## 2. COMMENTS & IDEAS South & East

Title	HEATHROW PREFERRED COMPONENTS NOV 2018: (2) COMMENTS & IDEAS: SOUTH & EAST	
Prepared for	Heathrow Strategic Planning Group	
Plan ref.	HPC-nov18-C&I-SE	
Version	V01	Version history
Issue date	14.12.18	V01 - 14.12.18 - KU
Drawn by	KU

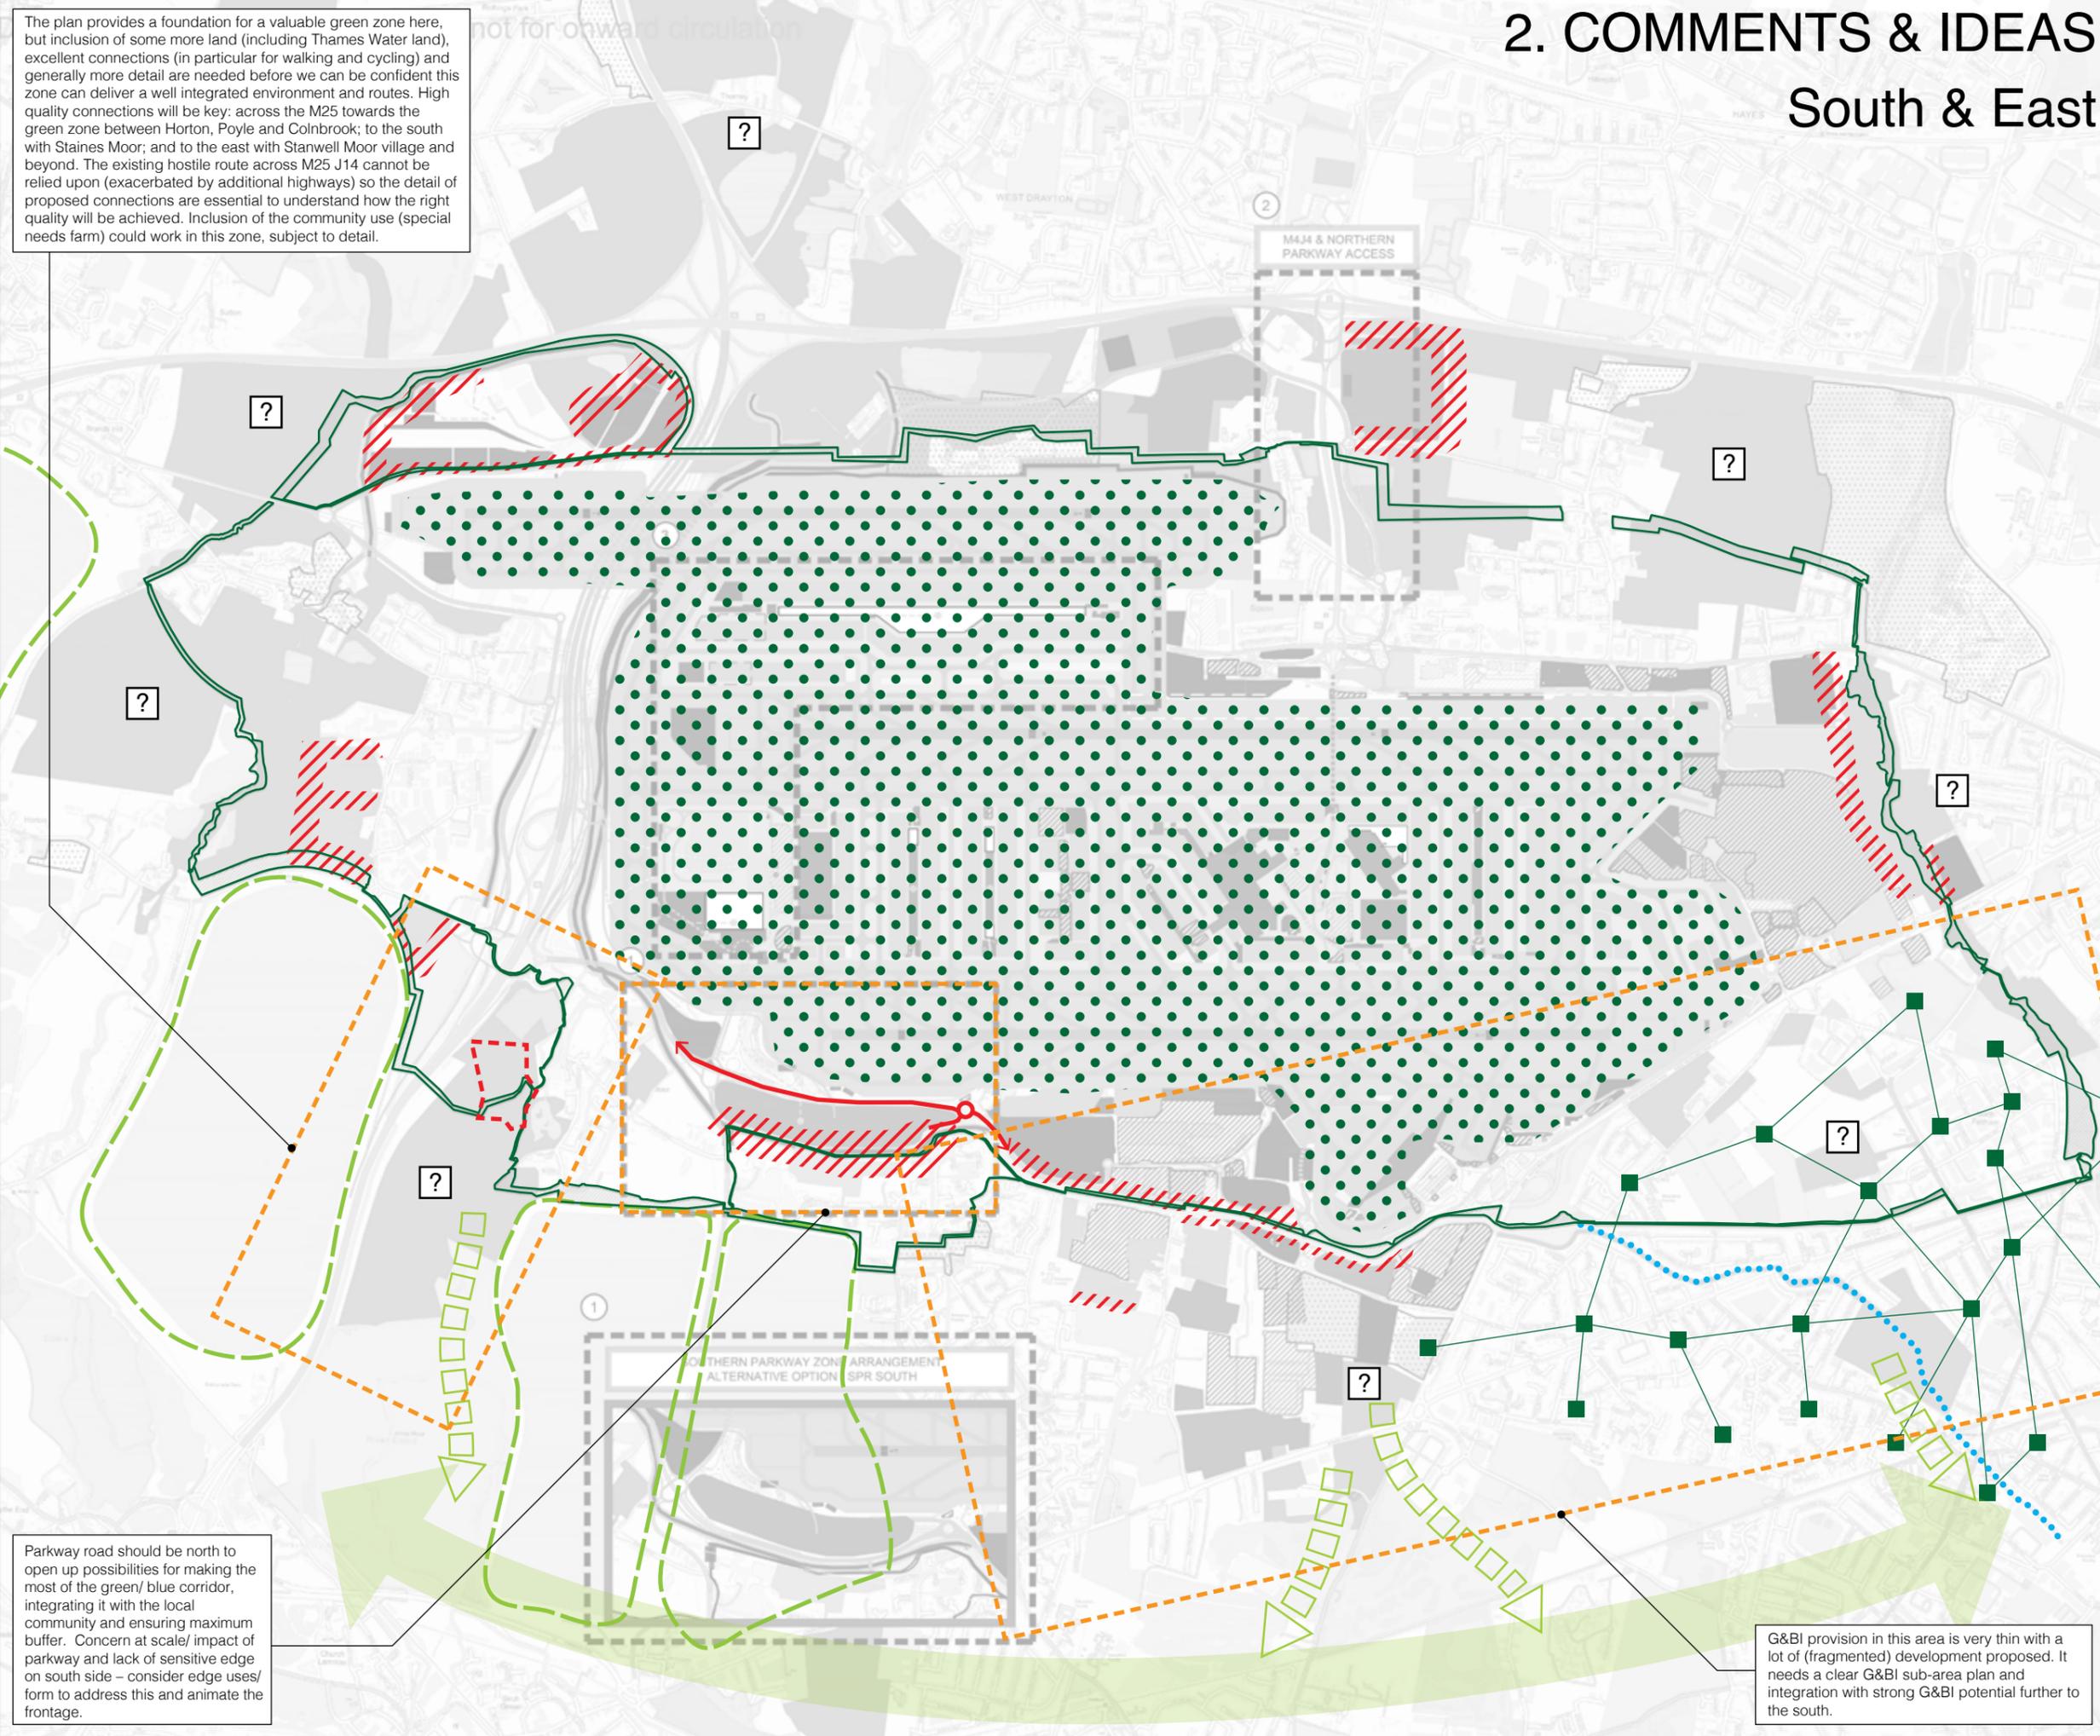
The plan provides a foundation for a valuable green zone here, but inclusion of some more land (including Thames Water land), excellent connections (in particular for walking and cycling) and generally more detail are needed before we can be confident this zone can deliver a well integrated environment and routes. High quality connections will be key: across the M25 towards the green zone between Horton, Poyle and Colnbrook; to the south with Staines Moor; and to the east with Stanwell Moor village and beyond. The existing hostile route across M25 J14 cannot be relied upon (exacerbated by additional highways) so the detail of proposed connections are essential to understand how the right quality will be achieved. Inclusion of the community use (special needs farm) could work in this zone, subject to detail.

Parkway road should be north to open up possibilities for making the most of the green/ blue corridor, integrating it with the local community and ensuring maximum buffer. Concern at scale/ impact of parkway and lack of sensitive edge on south side – consider edge uses/ form to address this and animate the frontage.

G&BI provision in this area is very thin with a lot of (fragmented) development proposed. It needs a clear G&BI sub-area plan and integration with strong G&BI potential further to the south.

- G&BI and habitat provision and species mitigation in the south is very thin. Mapping should be extended to show G&BI context (e.g. broader loop to south shown here, linking to existing assets). The impact (mitigation, surface transport and land use planning) is much wider than currently shown. It needs to be made clear what these corridors are connecting to.

- Greater connectivity with & improvement of green infrastructure beyond identified areas is required to secure comprehensive mitigation and integration (locations indicated are examples only).

- \*Investigate and pursue opportunities around reservoirs for recreation, increased biodiversity and improved access routes.
- \*Green Link:
  - Weak and narrow, particularly east-west to south of airport.

- Function (in general and in different section) needs clarifying.
  - Needs to link strongly with surrounding area.
  - Further work required to deliver 'network' link, beneficial public throughflow and true biodiversity opportunity.

- \*Green and Blue infrastructure on and off airfield should be linked and considered together. Use of on airfield green and blue infrastructure should be properly evaluated (among others, to mitigate heat island effect), including using it in the design and construction of buildings, such as green roofs and walls or within atria.

- Potential to invest in garden space and playing fields closer to the airport where it is difficult to create large areas of green infrastructure.
- Include Longford River in mapping and ensure provision in this area reaches HSPG Heathrow Area Landscape Framework aspirations.

- \*Function of planned green space unclear across the plan (areas with symbols are examples) – information needed. All assets should be assessed for potential for multiple benefits. How will these spaces be funded and managed in perpetuity? Quality should be min. national Green Flags Standard.

- \*Have design guidelines for where development meets green space. With the expectation of 20% green within any development, spend this wisely through joint working (bundling green space to be most useful). Ensure adequate space where they meet and ensure green corridors through built zones. Areas indicated are examples, the principle applies to all areas where development is proposed.

- Concern over suggestion of further building in what should be a recreation/ green area. Seeing the full picture and cumulative position (DCO, non-DCO and local plans) is essential for certainty on the green infrastructure provision.
